Re: Correction Letter
Sonny's Direct
Lee's Summit, MO

Permit No: PRCOM20253506
Project Title: SONNYS
Project Address: 2201 NE TOWN CENTRE BLVD, LEES SUMMIT, MO 64064
Parcel Number: 52500022800000000
Location / Legal Description: TOWN CENTRE LOGISTICS LOT 1 & TRACT A---LOT 1

This is a response to your Plan Review Conditions letter dated 8/29/25

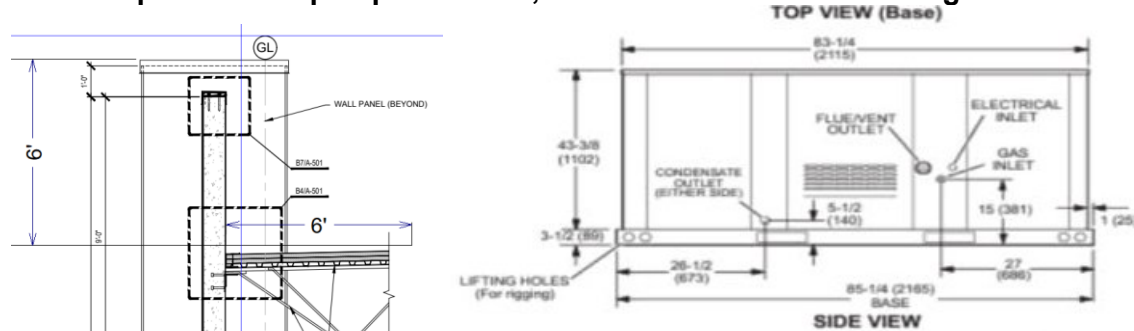
5. 2018 IMC 502.3 Battery-charging areas for powered industrial trucks and equipment. Ventilation shall be provided in an approved manner in battery-charging areas for powered industrial trucks and equipment to prevent a dangerous accumulation of flammable gases. *Action required: Provide exhaust system at battery chargers.*

Response: Ventilation for the battery chargers is shown on M2.01. Exhaust Fan #2 (EF-2) works in conjunction with Louver 2 (L-2).
